MIDTOWN PLAZA

SPACE NO. 240B

PROJECT SCOPE: NEW HOT TOPIC SPACE TENANT BUILD OUT, REMOVE NON-LOAD BEARING INTERIOR WALLS & INSTALL NEW NON LOAD BEARING WALLS. INSTALL TENANT FIXTURES, LIGHTING & TRACK LIGHTING. NEW HVAC WITH MECHANICAL DUCTS, WITHIN PREVIOUS TENANT USE/LEASED PREMISES.

LANDLORD COMMENT/S:

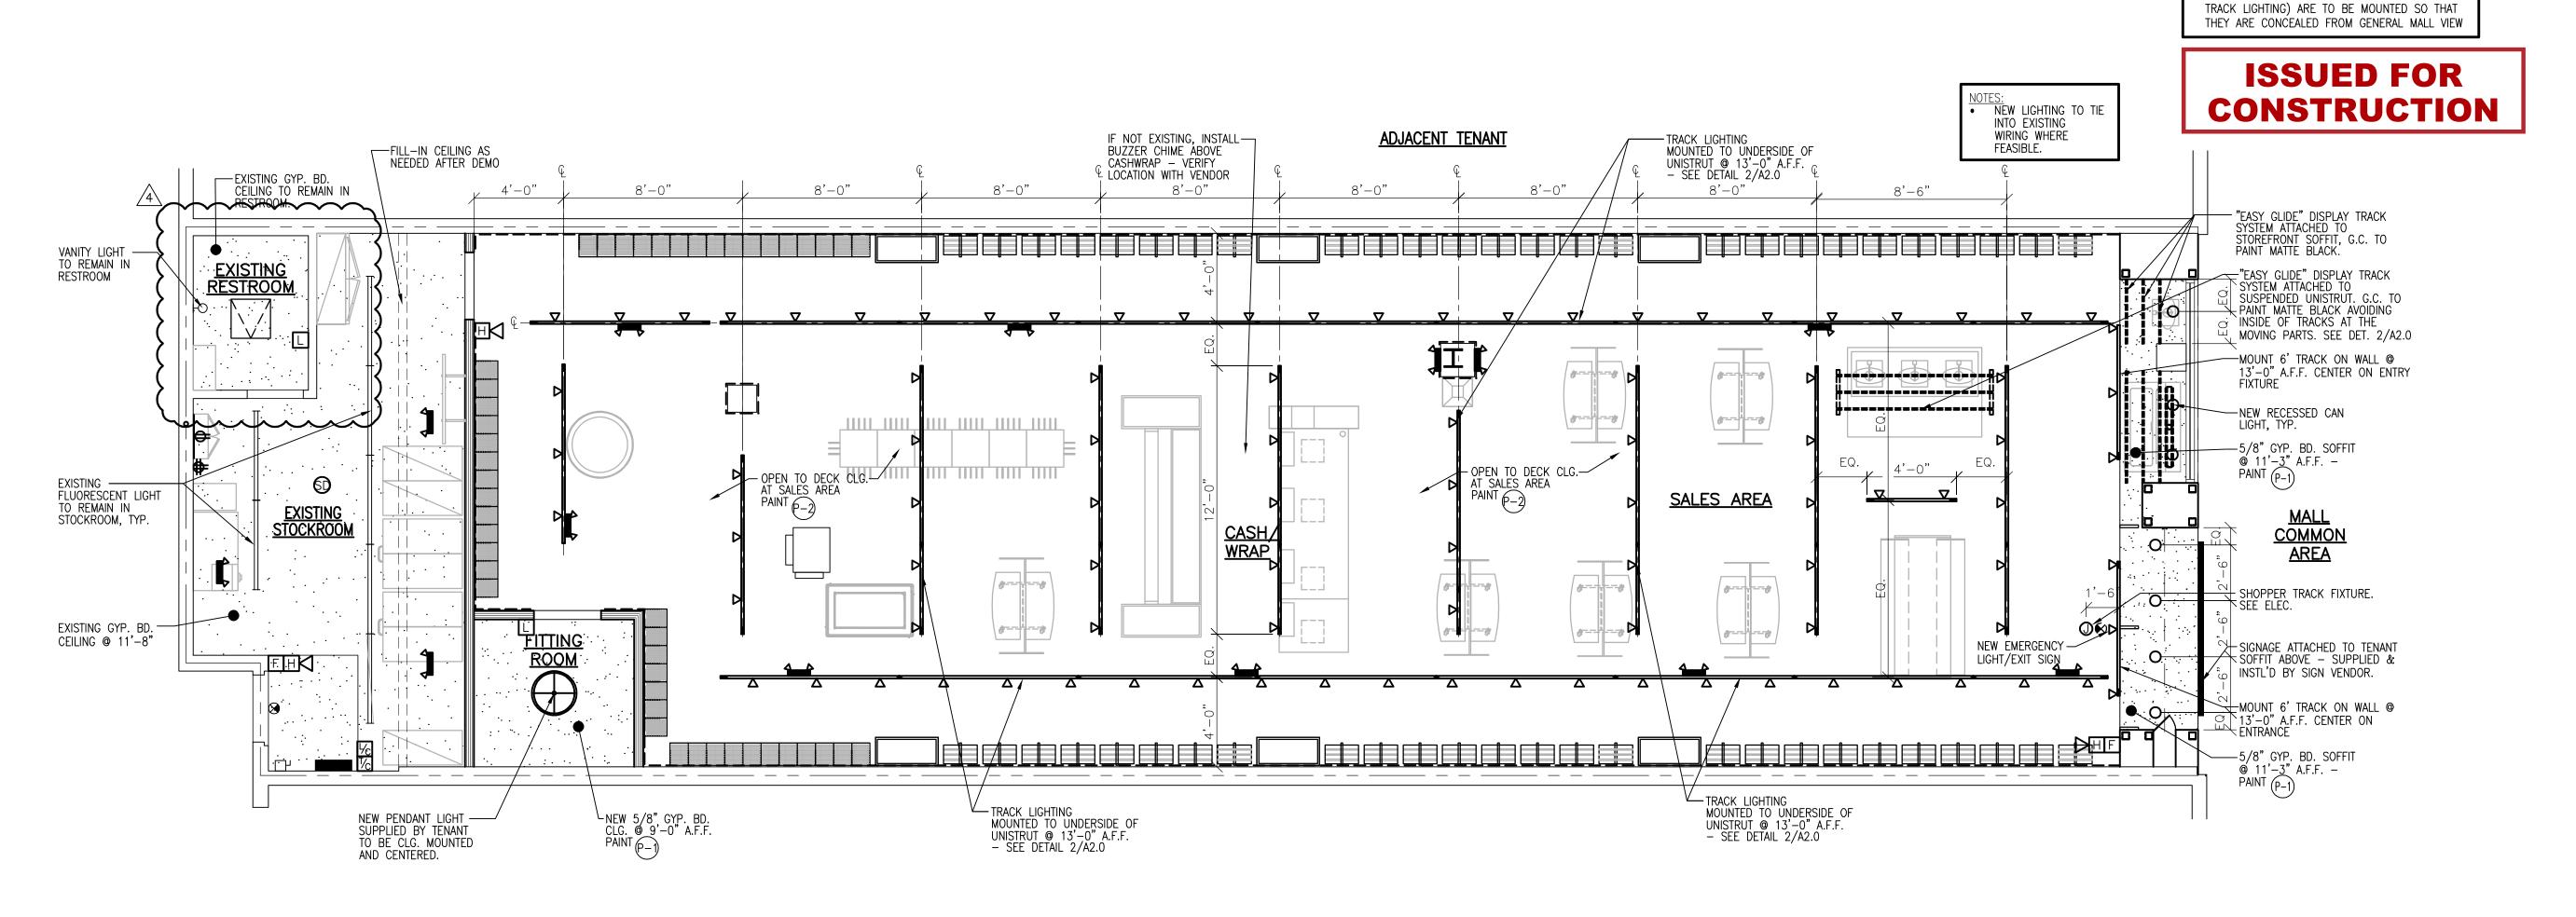
ENSURE TO INCLUDE FLOOR FINISH PLAN IN THE RESUBMISSION INCLUDING ALL MATERIAL SPECIFICATION. ENSURE THE PROPOSED FLOOR FINISH MEETS THE MOST CURRENT DCOF RATING FOR HIGH TRAFFIC

APPLICATION. ALL FLOOR TRANSITIONS ARE TO BE SMOOTH

THE LATEST LOCAL CODE REQUIREMENTS AND

ACCESSIBILITY STANDARDS. ENSURE ALL TENANT'S FIXTURES TO BE DETAILED AS TO NOT DISTURB OR MODIFY ANY EXISTING BASE BUILDING LANDLORD'S COMPONENTS.

REFLECTED CEILING PLAN SCALE: 1/4" - 1'-0"

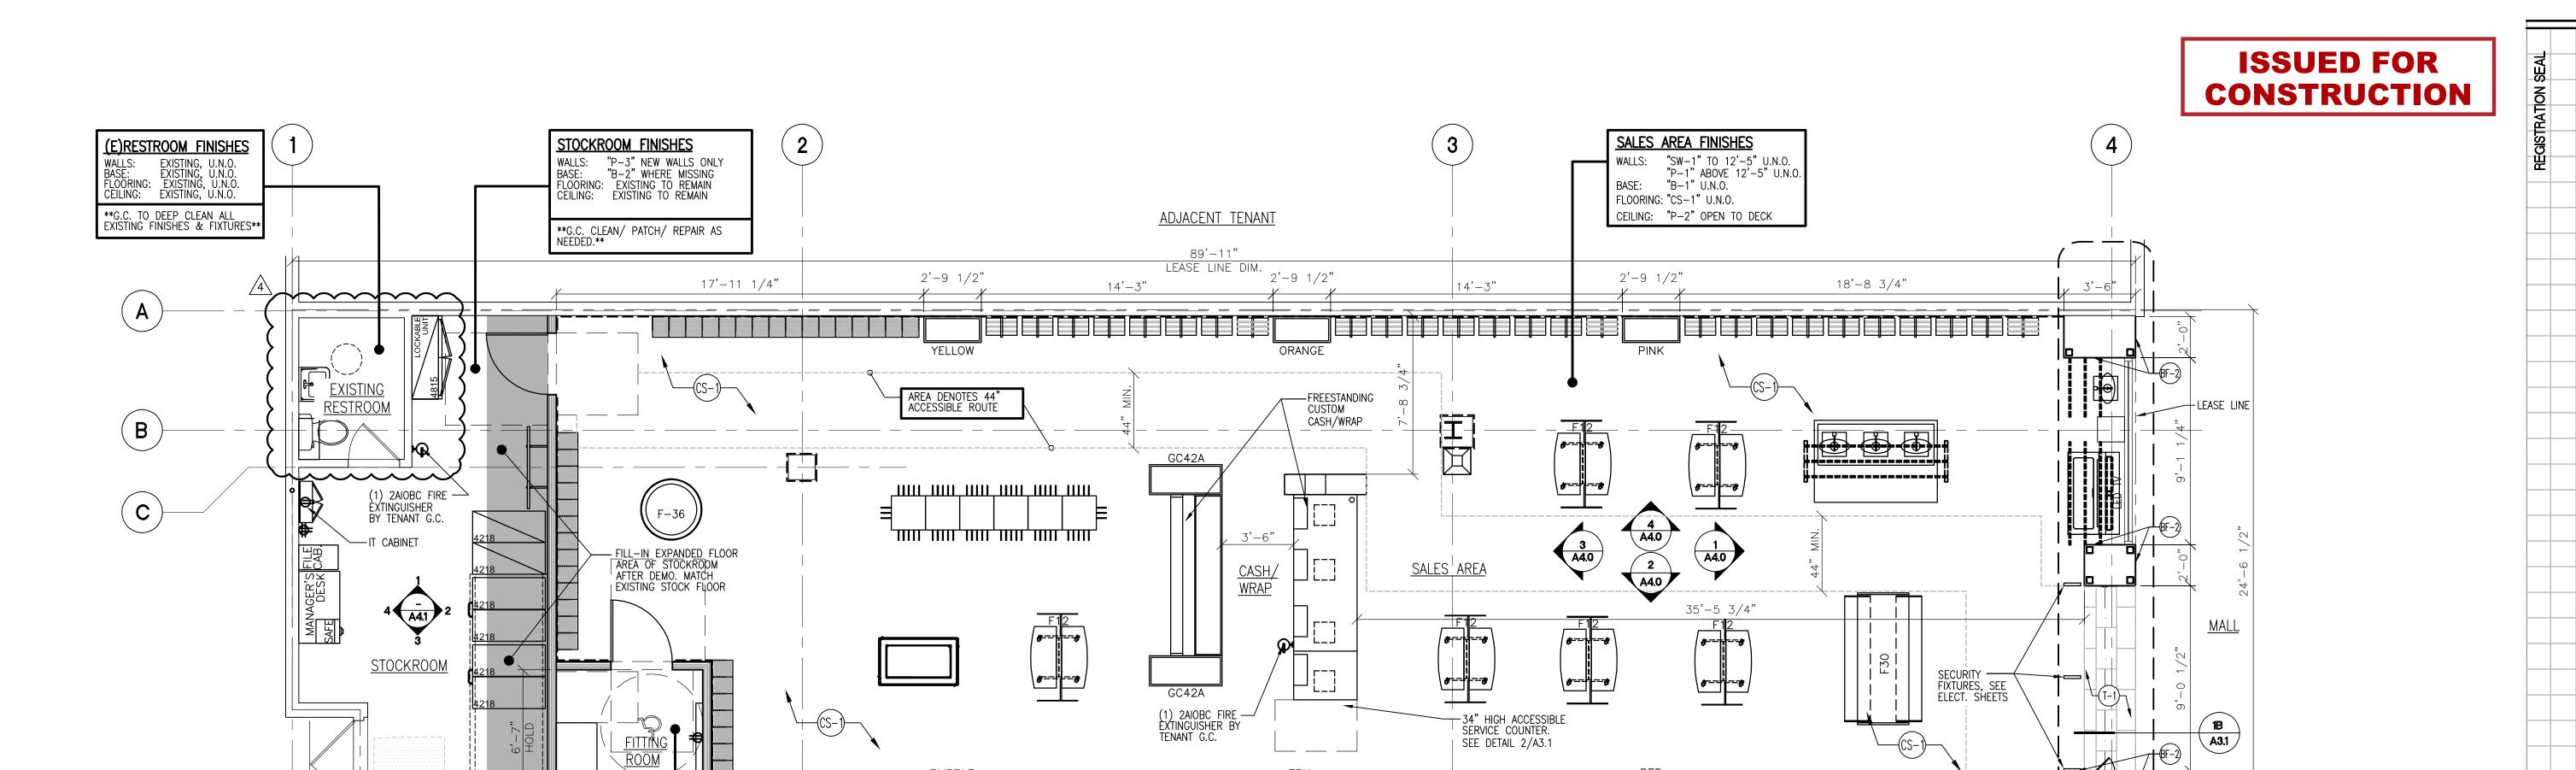
DISPLAY WINDOWS. ENSURE TO INCLUDE A TROUGH DETAIL.

THE REFLECTED CEILING PLAN SHALL INCLUDE ALL CEILING MOUNTED COMPONENTS SUCH AS

CEILING MOUNTED EQUIPMENTS (EG. SPEAKER, EXIT SIGNS AND ETC.) AND PROVIDE A SCHEDULED FOR

TENANT TO SITE VERIFY & TO ENSURE INTENDED CEILING HEIGHT CAN BE ACHIEVED.

ALL SUSPENDED LIGHTING MUST BE AT LEAST 8'-0" A.F.F. TO UNDERSIDE OF THE LIGHT FIXTURE

EXIST SIGNS ARE TO BE MOUNTED SO THAT THEY ARE NOT VISIBLE FROM GENERAL MALL VIEW.

UNDER NO CIRCUMSTANCES SHALL HANGERS BE ATTACHED TO ANY BASE BUILDING DECK, ROOF

PANS OR LANDLORD'S EQUIPMENT. GENERAL CONTRACTOR SHALL USE ONLY STRUCTURAL CHANNELS

FIXTURE / FLOOR FINISH PLAN

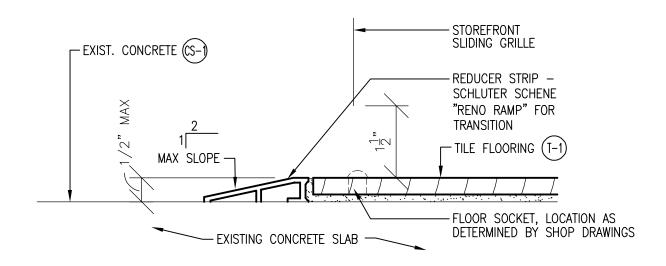
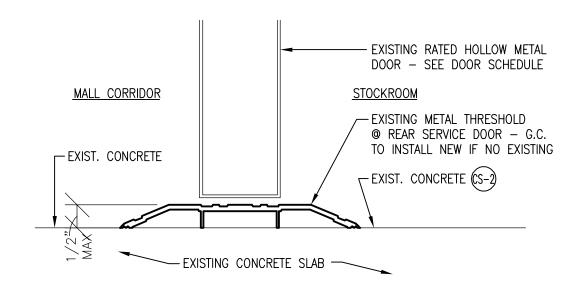
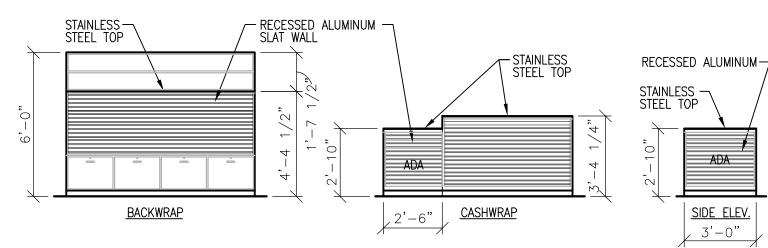
PROVIDE DETAIL DRAWINGS FOR THE TENANT FLOOR AND THE LANDLORD'S FLOOR TRANSITION. IN THE CASE THERE IS A FLOOR LEVEL CHANGE BETWEEN COMMON MALL

TENANT'S GC MUST VERIFY THE SITE CONDITIONS PRIOR TO FINALIZING DRAWINGS TO ENSURE THE DESIGN INTENT CAN BE EXECUTED. ENSURE TENANT'S GC TO PROPOSE QUALITY & DURABLE FLOOR FINISH THROUGHOUT THE STORE DESIGN AS SET OUT IN THE TENANT DESIGN CRITERIA. VINYL FLOORING IS NOT ACCEPTABLE. REFER TO CRITERIA FOR LANDLORD APPROVED MATERIAL FINISH. ENSURE TO INCLUDE WARRANTY, SLIP RESISTANCE AND SPECIFICATION OF PROPOSED FLOOR FINISH.

- THE FLOOR FINISHES PLAN SHALL INCLUDE THE INTENDED FLOOR FINISHES AND CLEARLY INDICATE THE LOCATION OF THE TRANSITION STRIP. ENSURE TO

INCLUDE A DETAIL DRAWINGS OF THE PROPOSED TRANSITION. - ENSURE TENANT FINISH FLOOR LEVEL IS SET FLUSH TO THE ADJACENT MAIN FINISH FLOOR LEVEL ACROSS ENTIRE LENGTH OF STORE ENTRANCE. NO TENANT FLOOR FINISH SHALL EXTEND BEYOND TENANT CLOSURE LINE. PROVIDE DETAIL DRAWINGS FOR THE TENANT FLOOR AND THE LANDLORD'S FLOOR

TRANSITION. - ENSURE APPROPRIATE SCHLUTER TRANSITION STRIP IS SPECIFIED BETWEEN EACH FLOOR MATERIAL CHANGE TO ENSURE A SMOOTH PATH OF TRAVEL. REDUCER STRIPS ARE NOT PERMITTED.

- IN THE CASE THERE IS A FLOOR LEVEL CHANGE BETWEEN COMMON MALL AREA AND TENANT SPACE, TENANT IS RESPONSIBLE TO BRING THEIR FLOOR FINISHES TO MEET LANDLORD'S FLOOR FINISHES AT THE SAME LEVEL. THE MALL FLOOR WILL NOT BE ALTERED.

INTENDED DESIGN IS ACHIEVABLE. - TENANT MUST VERIFY THE SITE CONDITIONS PRIOR TO FINALIZING DRAWINGS TO ENSURE THE DESIGN INTENT CAN BE EXECUTED.

1 STOREFRONT PLAN SCALE: 1/2' - 1'-0'

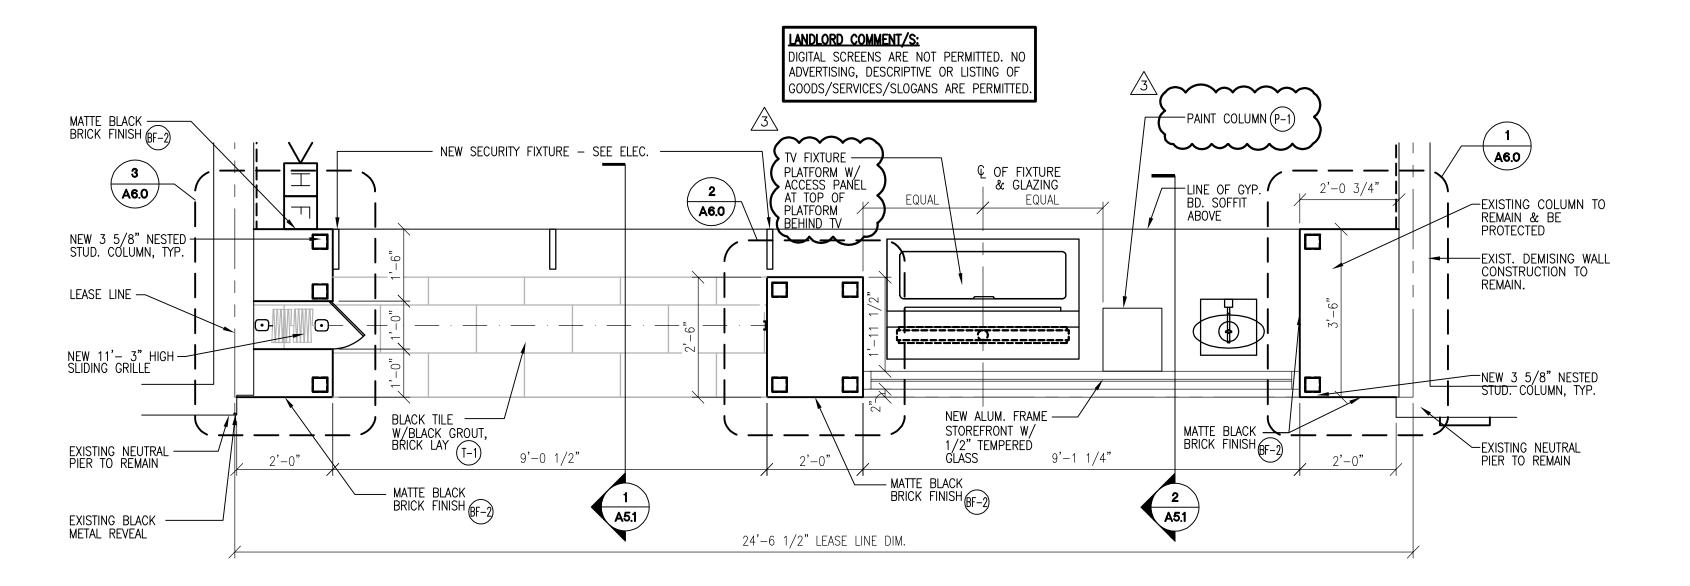
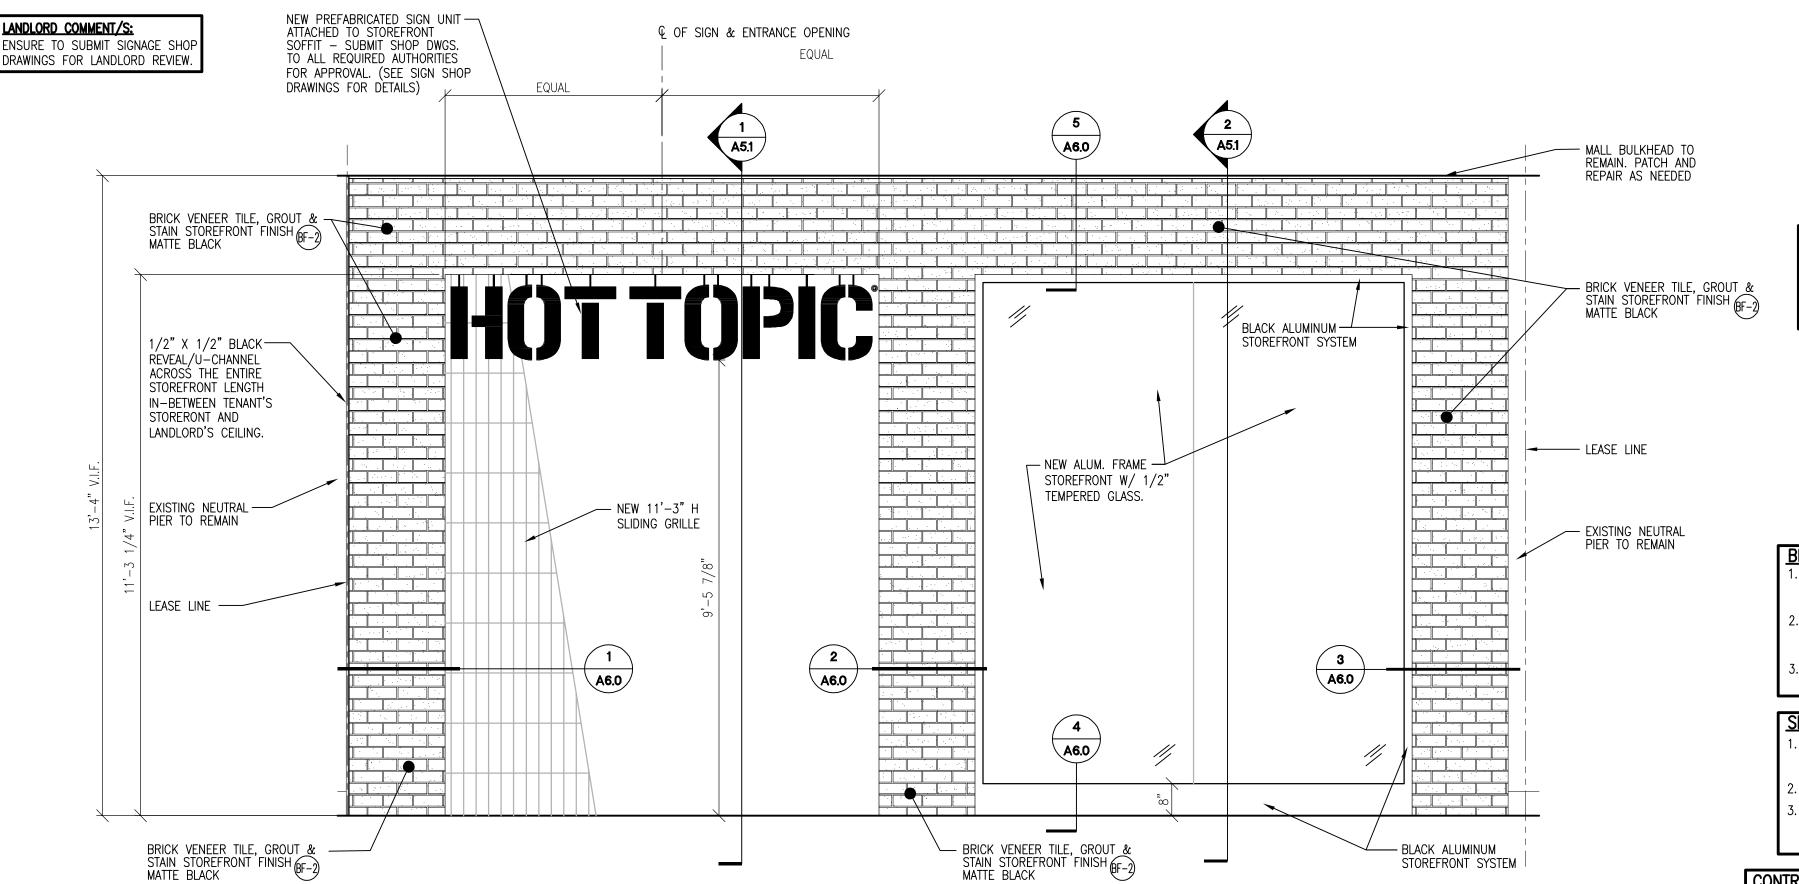
SUBMIT COMPLETE SHOP DRAWINGS & MOUNTING/CONNECTION DETAILS OF STOREFRONT SIGNAGE. ENSURE TO CONFORM WITH THE LOCAL CODE REQUIREMENTS.
 SIGNAGE MUST CONFORM TO CSA AND UL STANDARD. SUBMIT COMPLETE SIGNAGE SHOP DRAWINGS FOR REVIEW. COMPLETE SIGNAGE FINISHES AND SPECIFICATION MUST BE INDICATED ON DRAWINGS. ALL EXPOSED FACES AND RETURNS MUST BE SHOP FINISHED. PROVIDE ACTUAL FINISHES SAMPLE OF ROPOSED SIGNAGE FOR REVIEW.

- TENANT IS TO PROVIDE FULL DETAILS ON ALL TENANT'S PROPOSED PROMOTIONAL PERMANENT OR TEMPORARY SIGNAGE/GRAPHICS. ALL SIGNAGE/GRAPHICS (PERMANENT OR TEMPORARY) MUST BE CONTAINED WITHIN A FRAMED GLASS DISPLAY WINDOW THAT FORMS AS PART OF THE OVERALL STOREFRONT DESIGN.

- ENSURE SLIDING GRILLE TRACK AND DOORS ARE TO BE RECESSED AND INSTALLED FLUSH TO THE UNDERSIDE OF TENANT'S BULKHEAD.

- ALL STOREFRONT CONSTRUCTION IS TO BE SELF-SUPPORTING FROM THE FLOOR AND

ATTACHED TO LANDLORD'S STRUCTURE ABOVE FOR LATERAL BRACING ONLY.

ALL GLAZED STOREFRONTS SHALL CONFORM TO CODI REQUIREMENTS & CURRENT CAN/CSA STANDARDS. DRAWINGS MUST BE REVIEWED & STAMPED BY P.ENG LICENSED & PRACTICED IN THE PROVINCE OF SASKATCHEWAN.
